# Minutes of NMB RNN Trial Technical Workshop

Held on 3 May 2019

As part of ongoing planning for the Reduced Night Noise (RNN) Trial, a Technical Workshop was held with industry stakeholders to further engage on the trial. The following topics were discussed at the workshop:

**Figure 2** Trial concept example for 26L ILS Arrivals

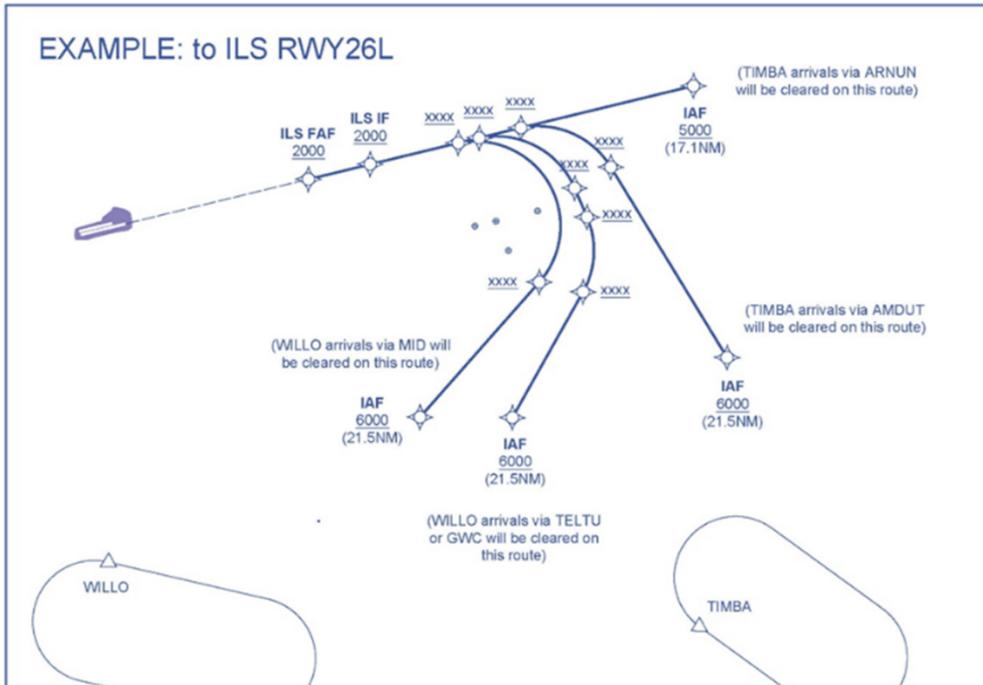
Trax presented the proposed 08R/26L and 08L/26R trial routes to the workshop (see Annex B). Trax explained that the routes were connected from proposed IAFs to the existing FAFs, although there is a disconnect between the end of the STARs and the start of the transitions. Through discussion, it was agreed that the disconnect should be clearly identified in the AIS supplement although the group present did not envisage any planning issues. In order to manage the disconnect and aid descent management, ATC must provide clearance as early as possible to the start of the transition. The supplement will advise which transition crews should expect based on their STAR. In an event where ATC cannot facilitate a clearance onto the RNP transition, crews should expect to be vectored to final approach as with normal operations. The workshop agreed that an ATC instruction should be prepared which identifies a minimum distance from touchdown by which the crew should receive clearance; this would aid continuous descent planning. Norwegian noted that they may require an extra procedure to fly the 'disconnected' routes which may take some time to prepare, however it is possible to achieve. It was noted that the transitions would end at the existing FAF (for the ILS procedures) and IF (for the RNAV ones). The existing ILS and RNAV approaches will not be changed.

The workshop discussed the 1.5NM level segment. Although a PANS-OPS requirement, for some time operators have been querying the need for it in modern Flight Management Computers (FMC) which currently extrapolate the glidepath to achieve a CDA without any level segment. Operators present said that from their perspective it was not required. A suggestion was made that, as this is a trial used to inform future design, we should investigate the omission of the level segment. Trax advised that the level segment is already built into the RNAV arrivals to the northern runway and to avoid re-design it would have to remain for the trial. However, there may be scope for omitting the level segment prior to the FAF on the transitions to the ILS procedures for the main runways. Trax/NATS agreed to prepare a proposal for NATS to present and discuss at the upcoming Lead Operator Group meeting on 21 May 2019.

Trax confirmed that the joining points illustrated on the procedure lie beyond the minimum 10NM night-time joining point<sup>2</sup> as required by the DfT. On comparison of the proposed routes, it was noted that the northern routes are only subtly different to the southern routes. The workshop discussed naming conventions for the waypoints and agreed that one chart of four transitions should be developed for each runway. Further to this, it was agreed that the trial supplement should clearly state that 'clearance on to the transition should not constitute clearance for the final approach'. Trax agreed to investigate suitable 5-letter names for the proposed trial routes.

Post-meeting note: Updates have been made to 26L/R charts since this workshop.

**Action 3:** Trax to prepare a proposal for removal of the 1.5NM level segment prior to the FAF from the 08R/26L ILS approach procedures. NATS to present this proposal for discussion at the upcoming Lead Operator Group meeting.

**Action 4:** Trax to investigate suitable 5-letter names for the proposed trial routes.
